# KEENE INFRASTRUCTURE IMPROVEMENTS **PHASE 2 PRELIMINARY DESIGN** **CENTRAL SQUARE**

MSFI COMMITTEE MEETING

MAY 08, 2024

# KEENE PHASE 2 | CENTRAL SQUARE DESIGN REVIEW WORKSHOP #3

## SIGNAL PHASING - LEFT-TURN ALTERNATIVE

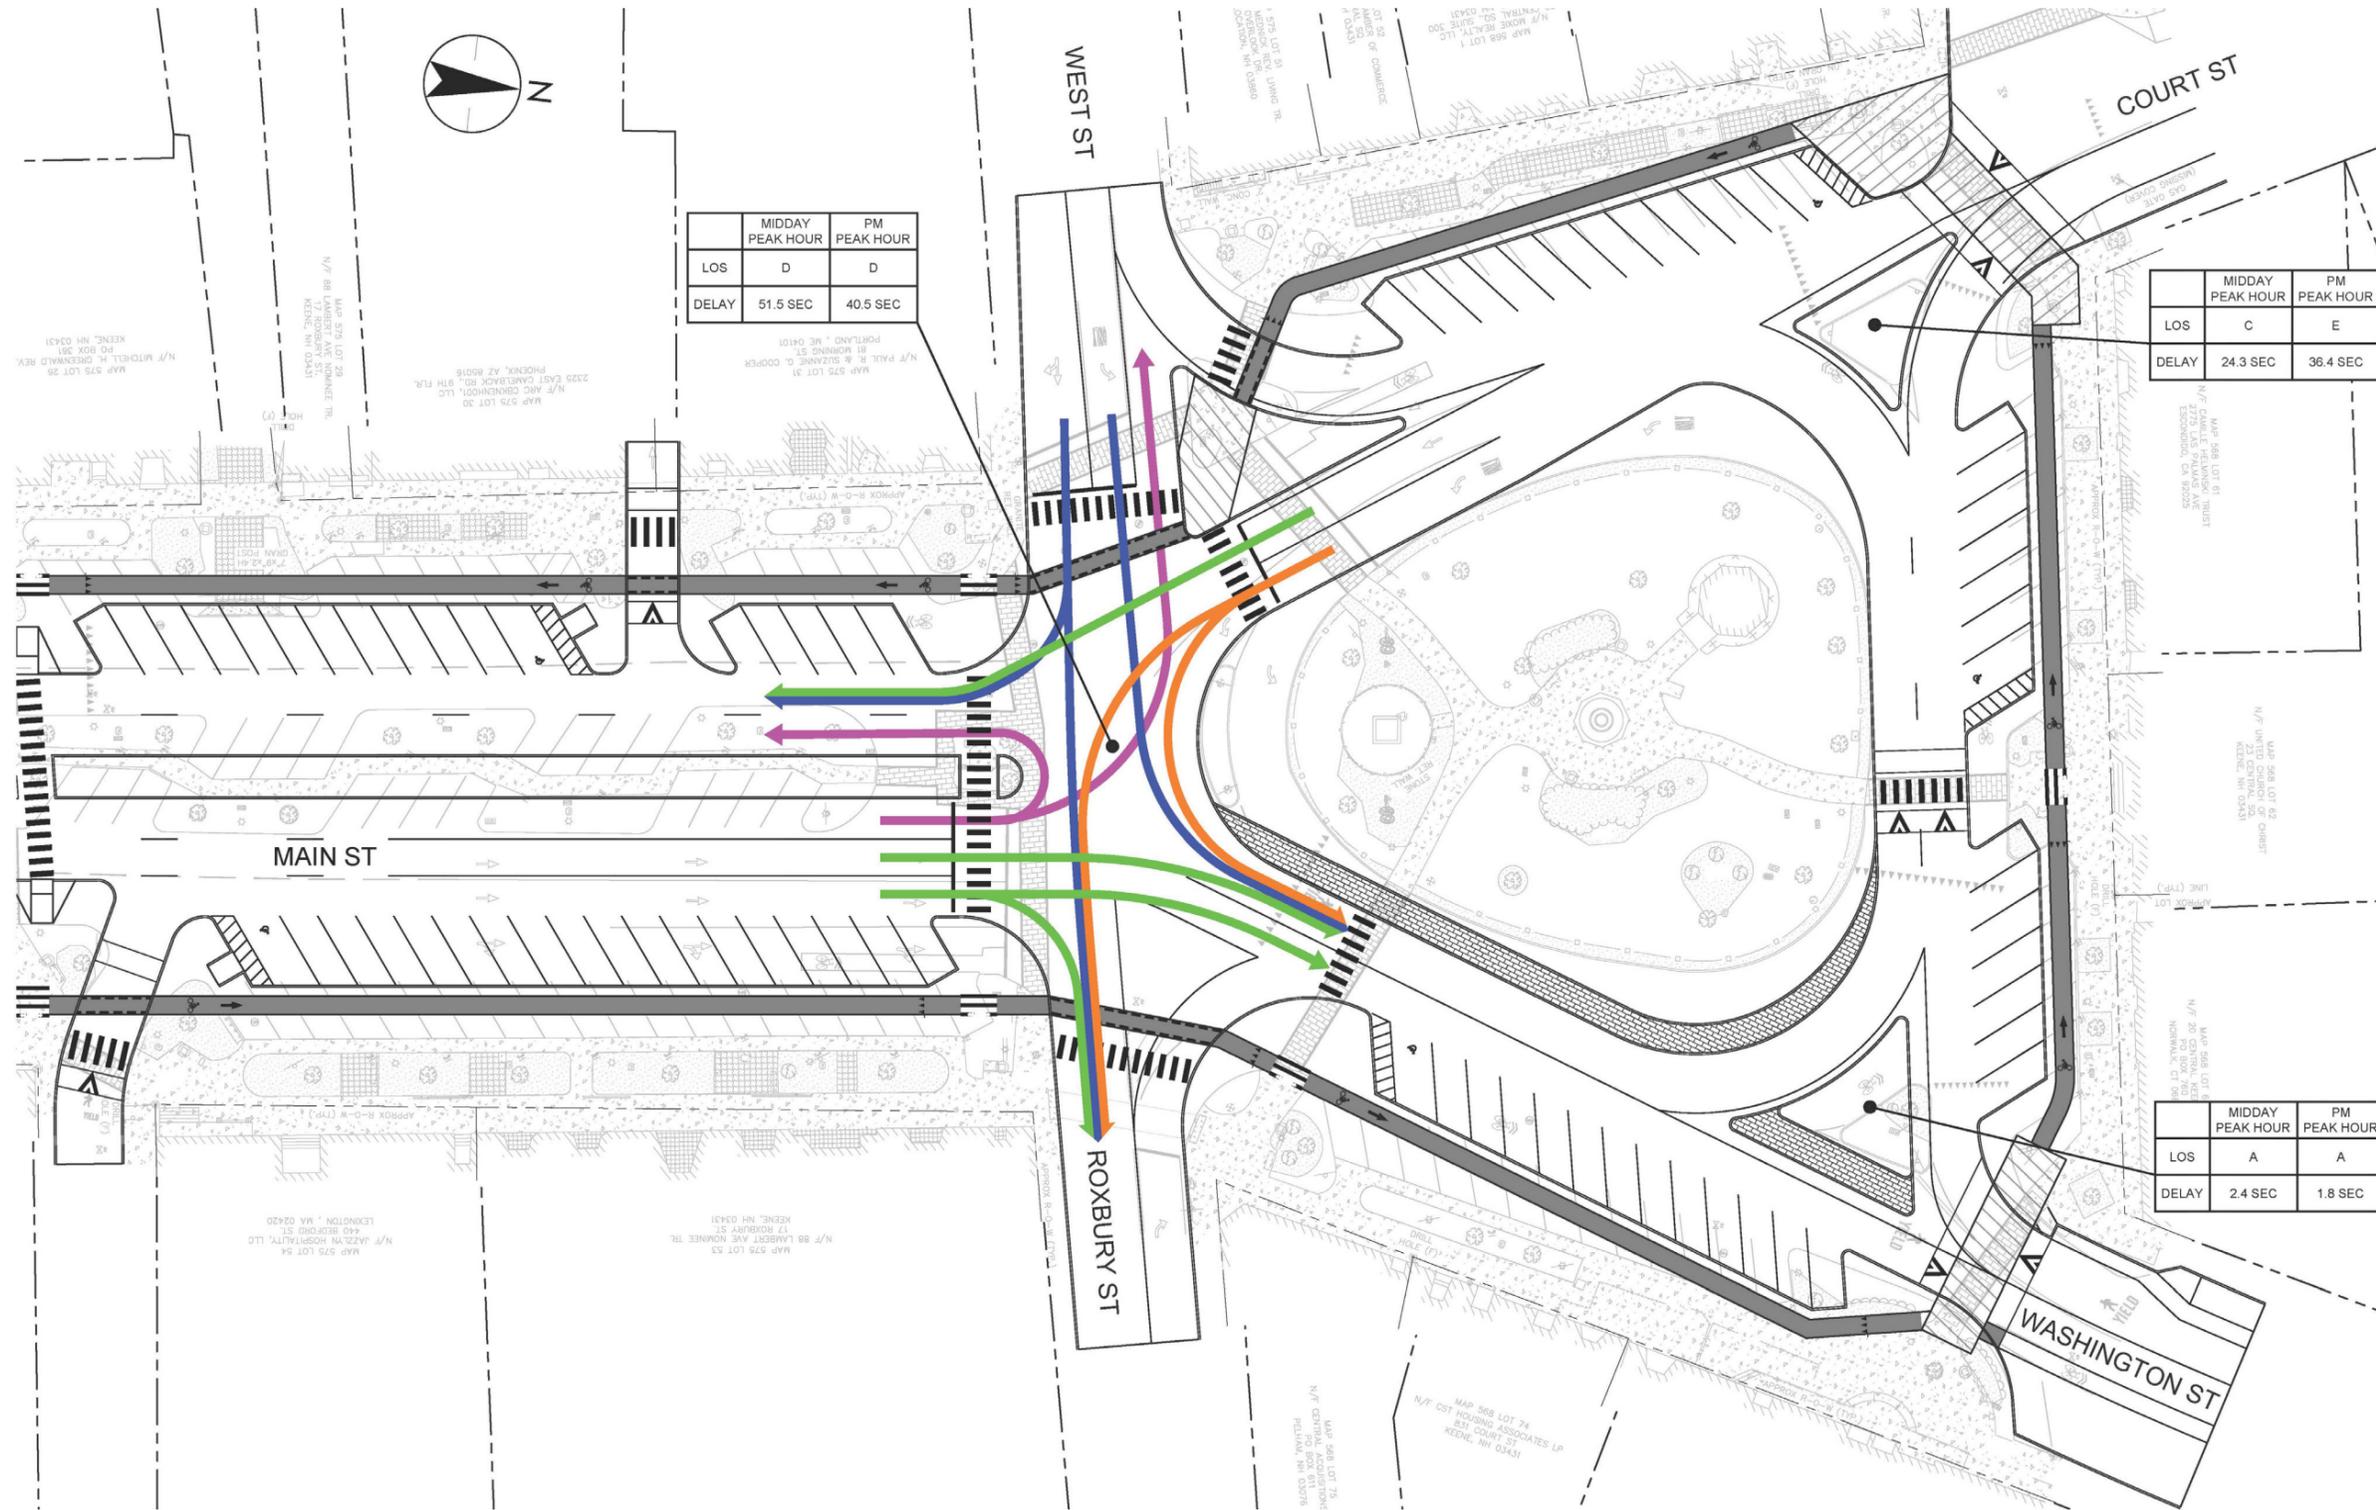
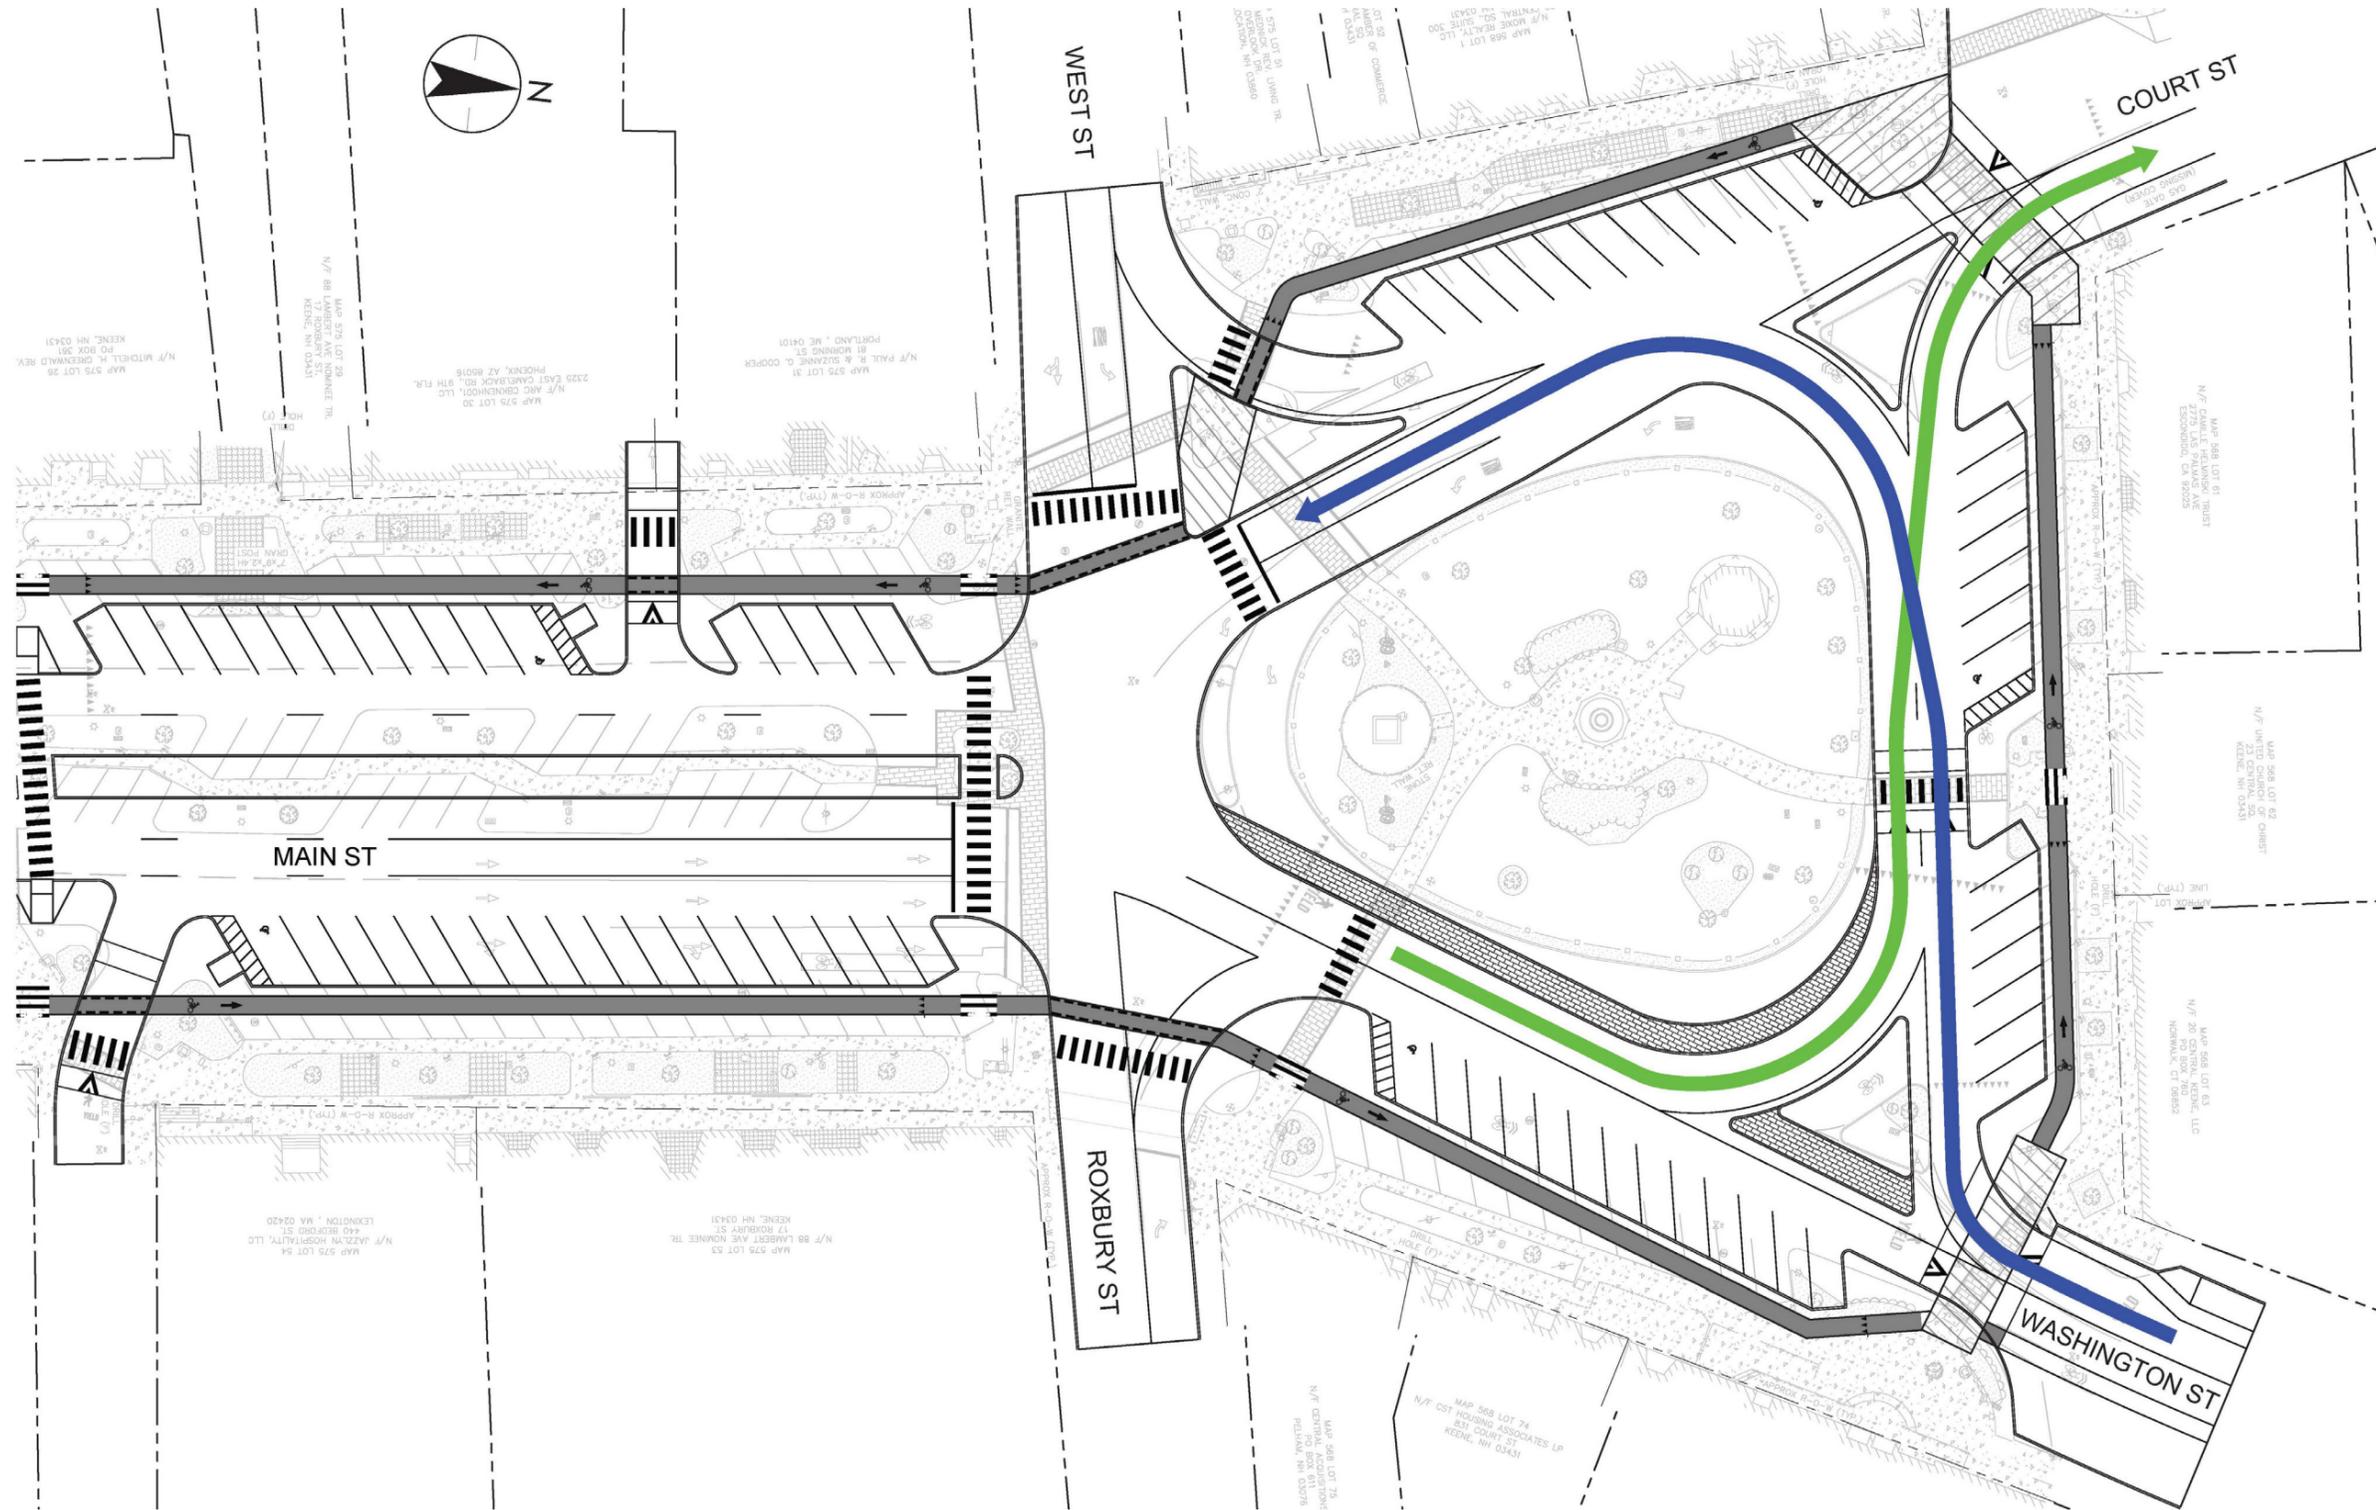
- The U-turn south of the intersection had the most support of the U-turn alternatives.
- The single/double lane across the top of the square was mixed, about 50/50 between the two alternatives.
- General concern that reducing from two southbound through lanes to one will create backups along Court and across the top of the Square.
- Strong support for the raised crosswalks and RRFB(Rectangular Rapid Flashing Beacon) as shown.
- Concern with reducing to a single left turn lane from crossover to Court/West Street.
